# CITY OF ALBUQUERQUE

**RE: Lot 3 Block 3 Unit 22 SAD 228  
6328 Camino Alto NW  
Volcano Cliffs Subdivision  
Grading and Drainage Plan  
Engineers Stamp Date 4/16/18 (D10D003R3)**

Based upon the information provided in your submittal received 4/16/18, this plan cannot be approved for Grading Permit until the following comments are addressed.

ENGINEER'S SEAL	Title 6328 CAMINO ALTO NW	DRAWN BY
	GRADING AND DRAINAGE PLAN	DATE
	<i>RHD Engineering, LLC</i> 4305 Purple Sage Ave. NW ALBUQUERQUE, NM 87120 (505) 288-1621	SHEET # 1 of 1
	Richard Dourte P.E. #10854	JOB #

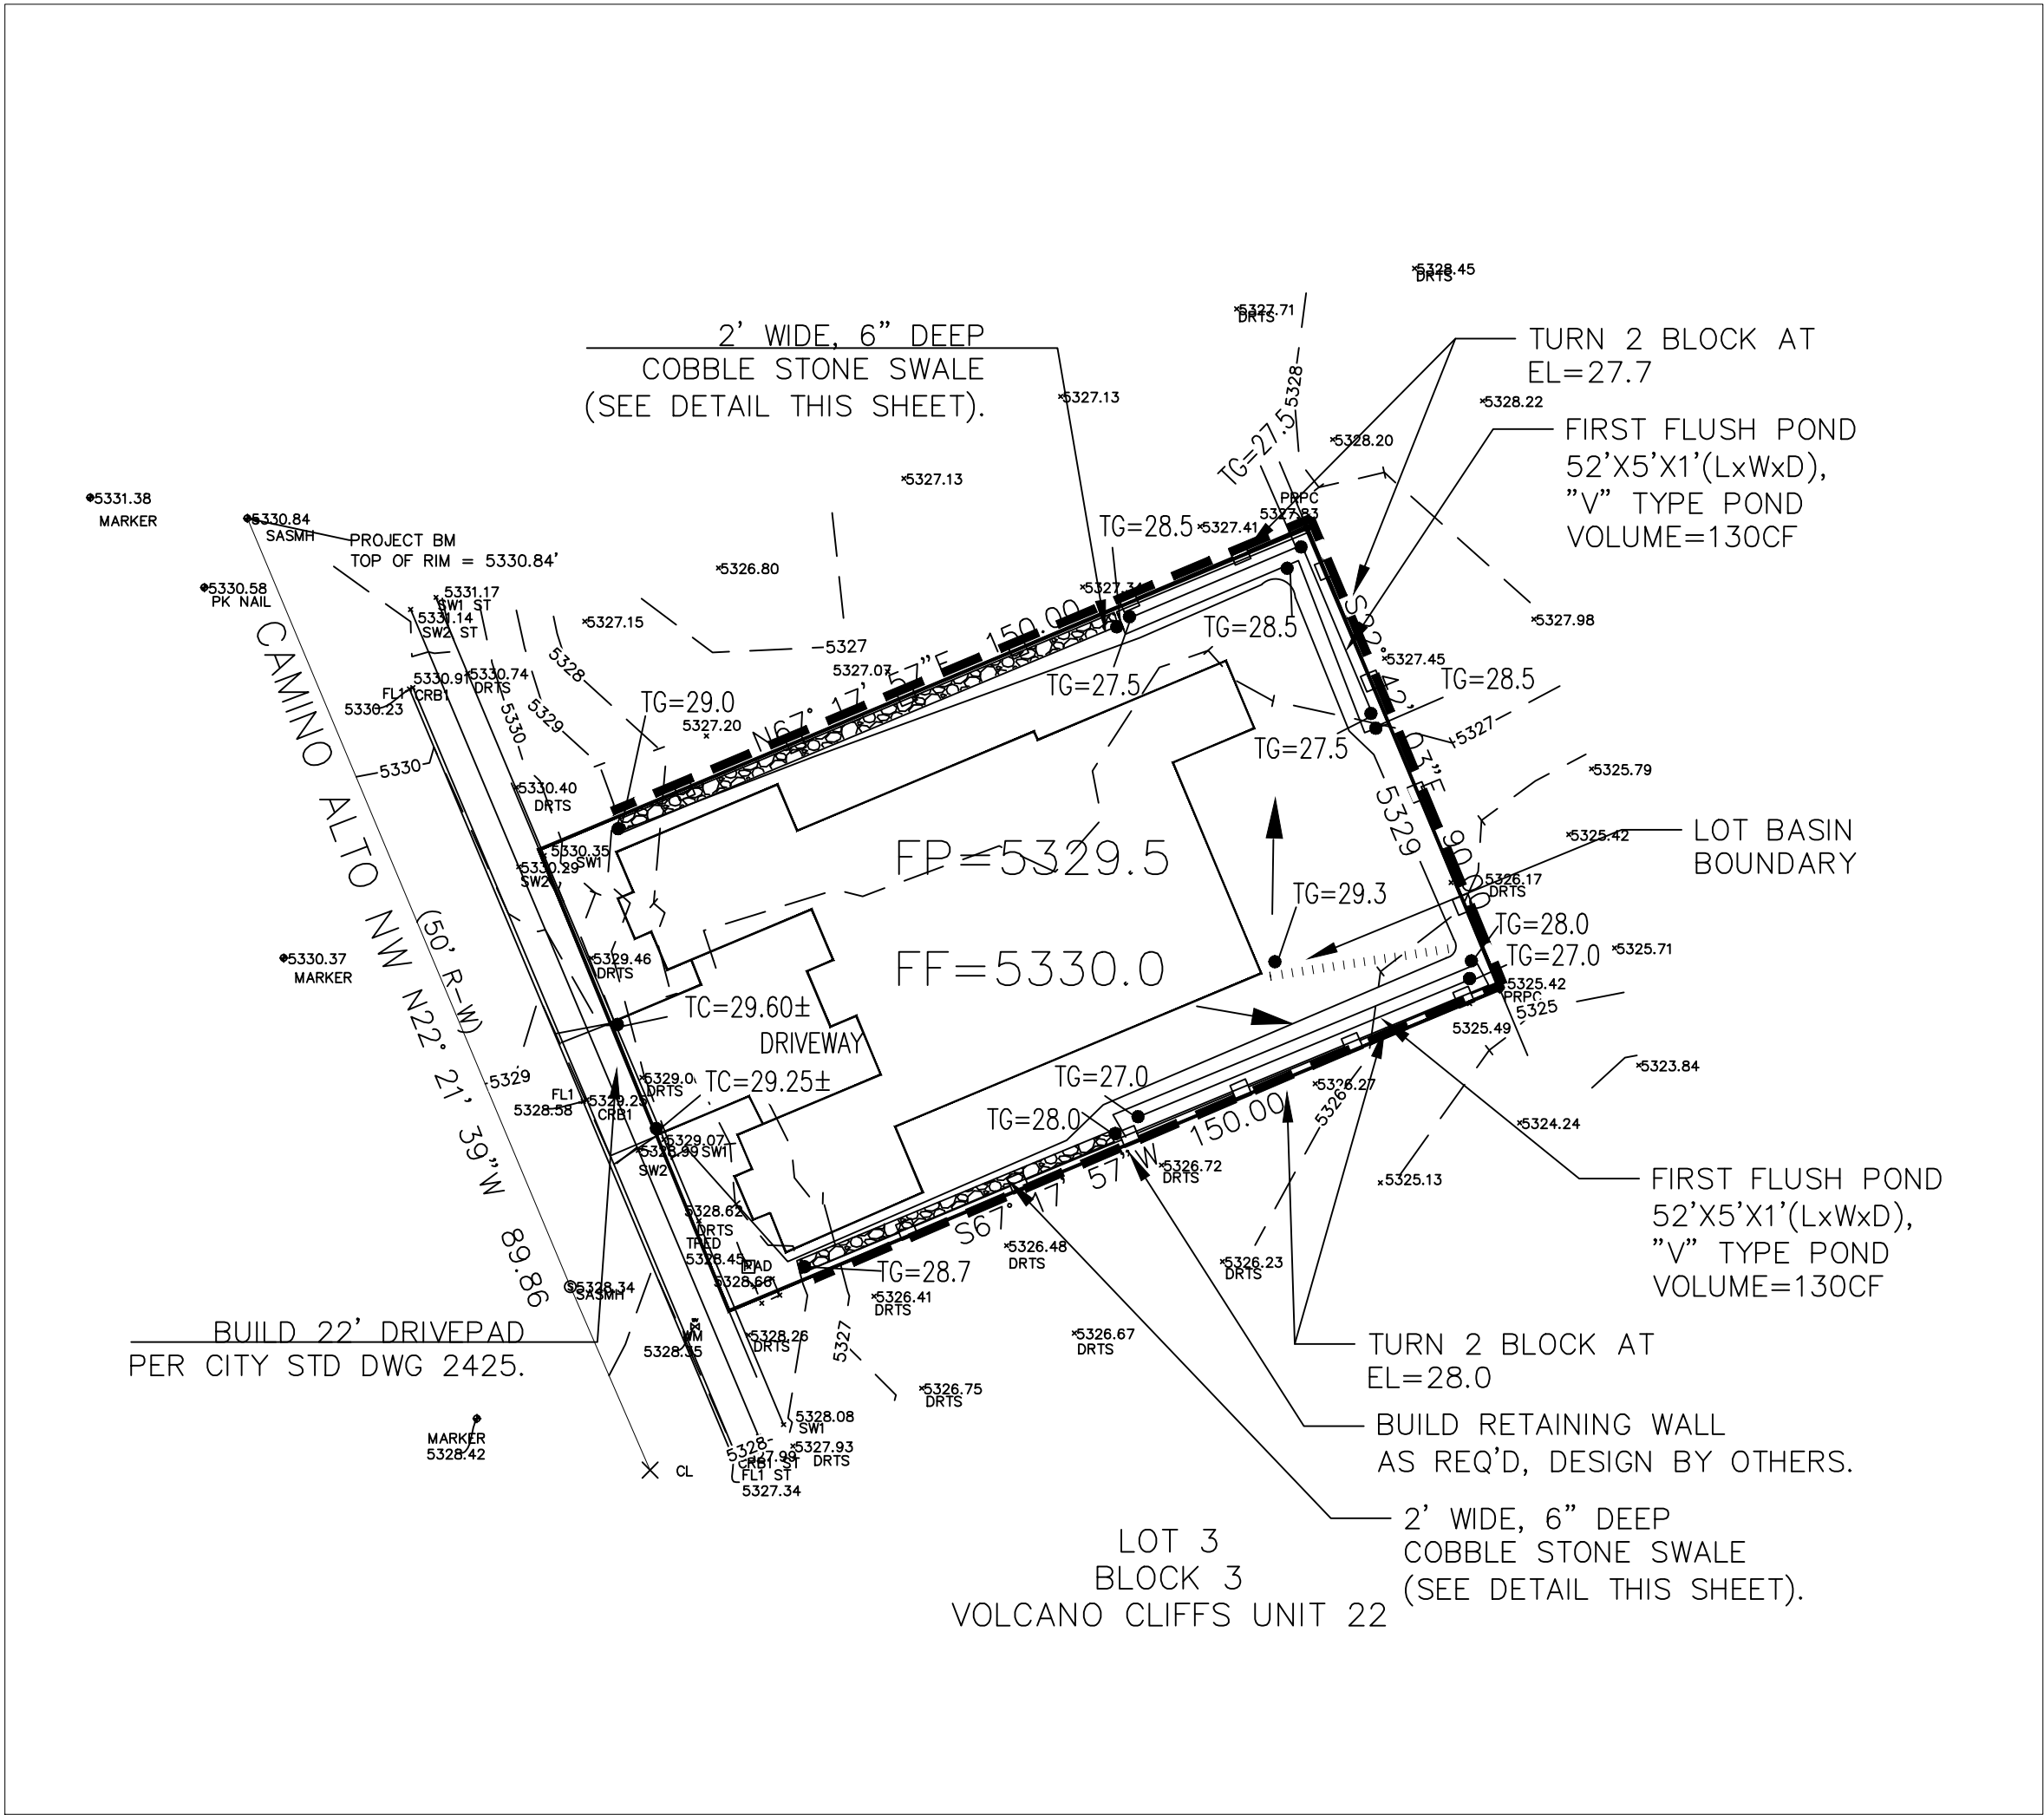
- Place turn blocks 3" above grade.
- Provide a note stating that a permit is required for the retaining wall and any future garden wall. This is the plan to follow dated 4/16/18 when applying for a perimeter block wall.
- Provide a cross section of the retaining walls showing location of wall pertaining to the lot lines. If encroaching into adjacent lots a written letter of approval from owners of the adjacent lots is required.
